Item 7.**Section 4.55(2) Modification Application 38-44 Mountain Street, Ultimo - D/2020/1288/A**

File No.: D/2020/1288A

Figure 14: Proposed roof plan

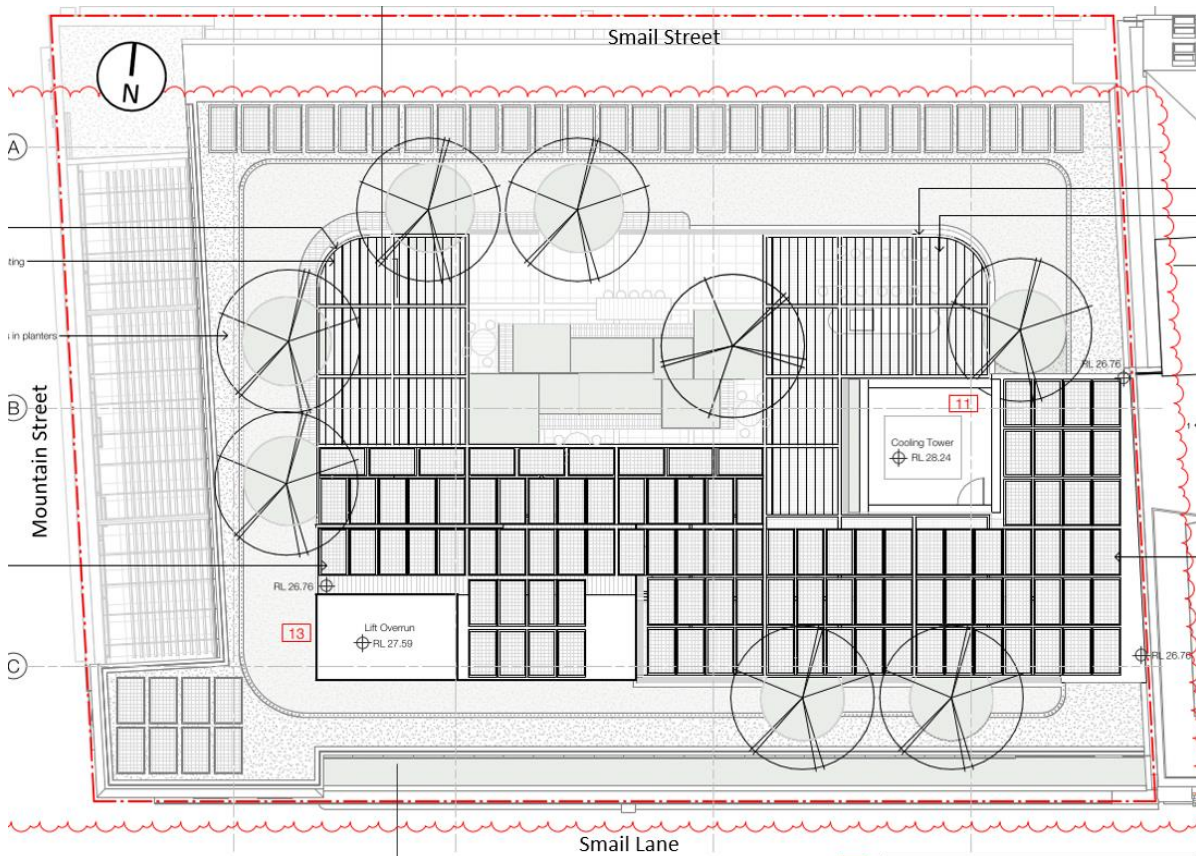
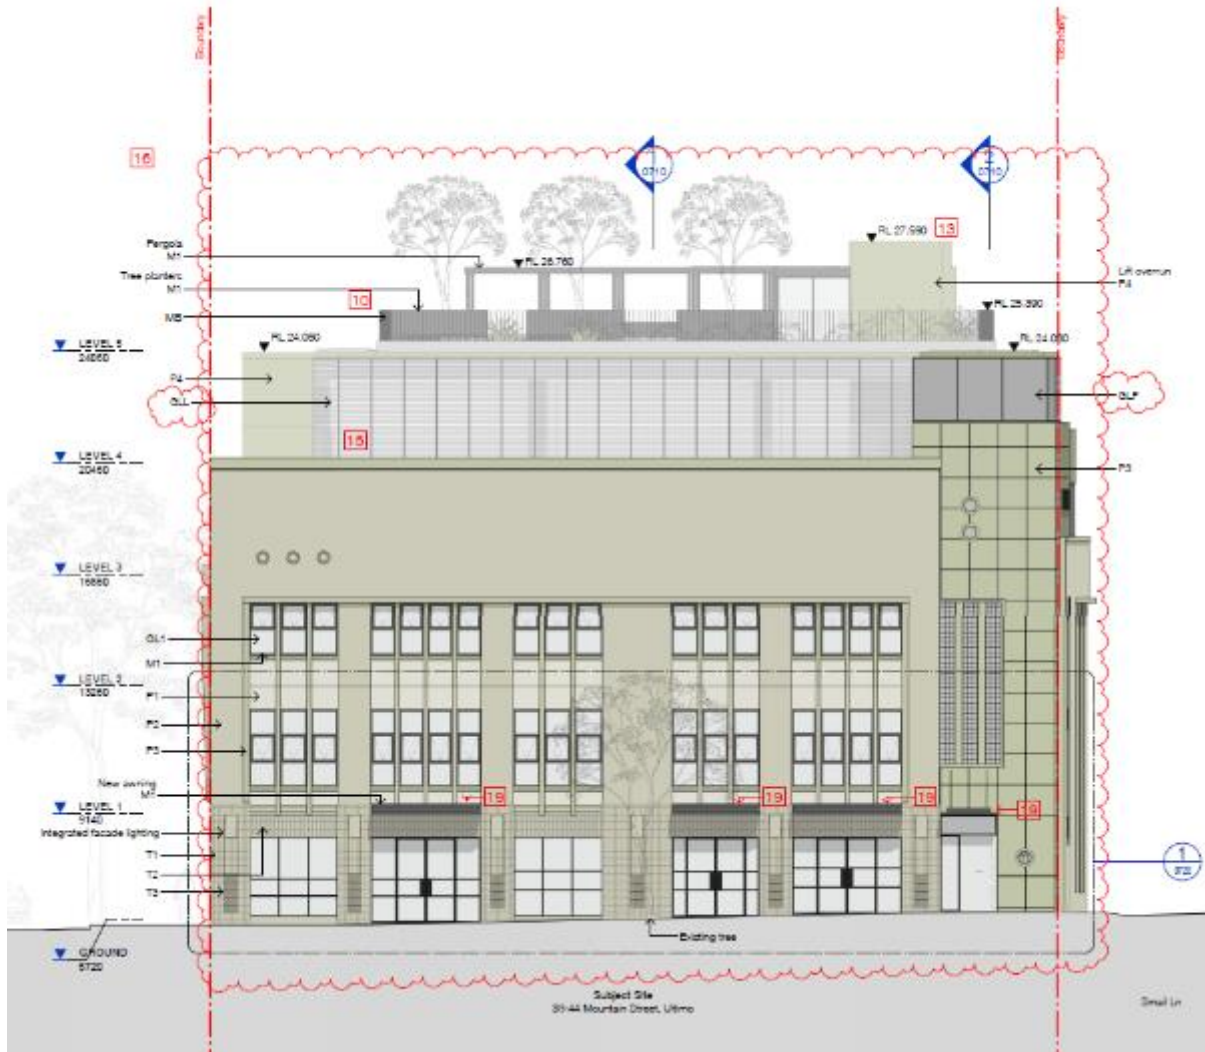
- 44. The proposed building height represents an increase of 1.065m upon the existing approved building height and would become the tallest building element compared to the approved building form under D/2020/1288. However, as the cooling tower is generally centralised in the building's roof terrace, the proposal does not introduce excessive bulk and overshadowing and does not unreasonably interfere with views.

- 45. A proposed elevation of the site demonstrating the proposed cooling tower is provided below in Figure 23.
- 46. The structure does not generate additional gross floor area, or trafficable space and does not prevent the proposal from achieving conditioned tree canopy requirements.

- 47. As such, the proposed cooling tower and the proposed modification to the approved building height is supported.

Figure 24: Proposed awning design along Mountain Street.

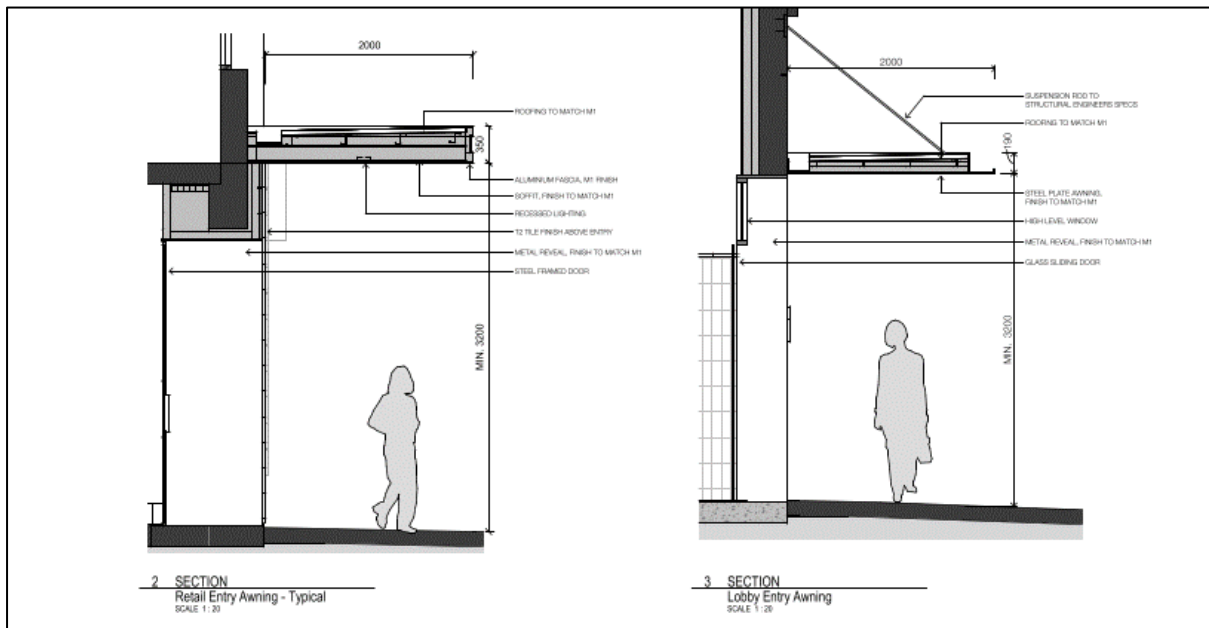
51. Condition 2(a) of the existing consent requires awnings located at street level entrances along Mountain Street are amended to comply with Section 3.2.4 of the Sydney DCP 2012 or be deleted. The revised design is to be to the satisfaction of Council prior to the issue of a Construction Certificate.
52. The applicant has included 1:20 diagrams of proposed the awnings within this S4.55 modification application. The applicant proposes the inclusion of the design in the modification and proposes the deletion of Condition 2(a). The diagrams are located below.

53. Council's Heritage and Urban Design Units have reviewed the proposal and advised that the proposed design will interfere with existing facade horizontal and vertical trim located above the entrances to the site. The trim is shown in the image in Figure 25.

54. The Heritage Unit has advised that the building trim is a significant feature of the building's 'contributing' status under the Sydney DCP, within the Mountain Street Heritage Conservation Area.
55. The existing condition is not recommended to be deleted. This will enable the applicant to submit revised plans and demonstrate an awning design which complies with the Sydney DCP and prevents interference with existing trim.
